ADA Curb Ramp New Construction Inspection Form (Parallel)

NW 309th

24952.54

Turel

PARALLEL RAMP (PL)

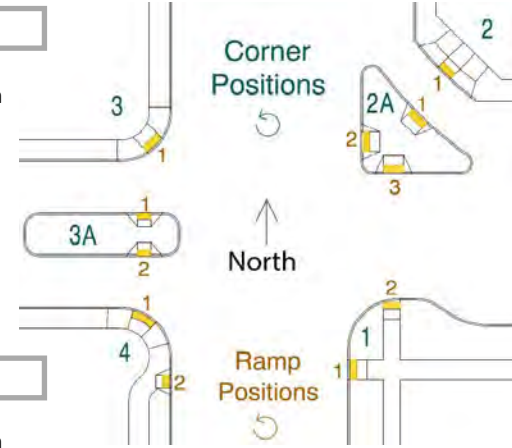
3.6 \leq 2.0% ☐ $>$ 2.0% ☒

☐ \leq 2.0% ☐ $>$ 2.0% ☒

N Y ☐ N ☒

4.6 \leq |5.0%| ☐ $>$ |5.0%| ☒

N Y ☐ N ☒

2.2 \leq 2.0% ☐ $>$ 2.0% ☒

2.6 \leq 2.0% ☐ $>$ 2.0% ☒

3.9 \geq 4.0' ☐ $<$ 4.0' ☒

N \geq 5.0'*1 ☐ $<$ 5.0'*1 ☒

Comments:

No Td.
